TMS320F2837xS Real-Time MCUs Silicon Errata

Silicon Revisions C, B

Figure 3-4. Placement of Series Termination Resistor and Pullup Resistor

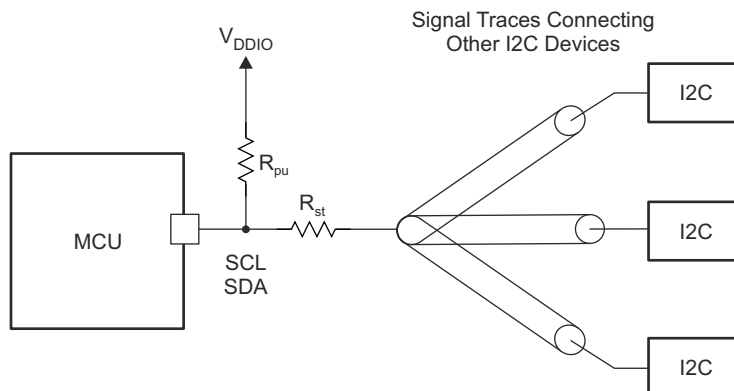
Insert series termination resistors on the SCL and SDA signals and locate them near the SCL and SDA terminals. The SCL and SDA pullup resistors should also be located near the SCL and SDA terminals. The placement of the series termination resistor and pullup resistor should be connected as shown in [Figure 3-4](#).

Figure 3-5. Undesired Trip Event and Blanking Window Expiration

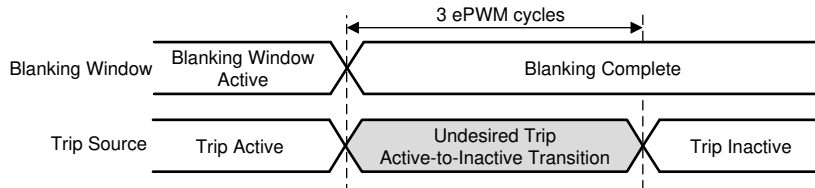
The blanking window is typically used to mask any PWM trip events during transitions which would be false trips to the system. If an ePWM trip event remains active for less than three ePWM clocks after the end of the blanking window cycles, there can be an undesired glitch at the ePWM output.

Figure 3-5 illustrates the time period which could result in an undesired ePWM output.

Figure 4-1. Single-Ended Input Model

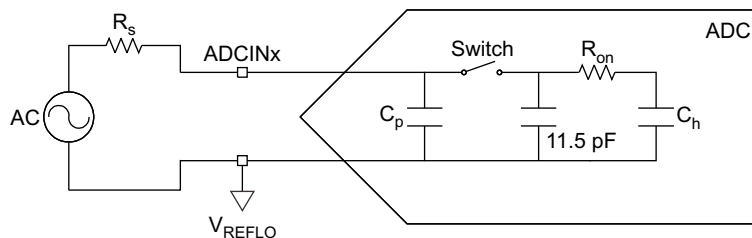
The ADC input model should be used to select the sample-and-hold (S+H) duration for each ADC input. For the revisions affected, if the currently converting channel is an even-numbered channel and the previously converted channel was an odd-numbered channel (or vice versa), then the 12-bit input model will not accurately predict ADC input performance. Under these conditions, an additional capacitance should be added to the model. This capacitance has a value of 11.5 pF and should be placed between the S+H switch and R_{on} as shown in [Figure 4-1](#).
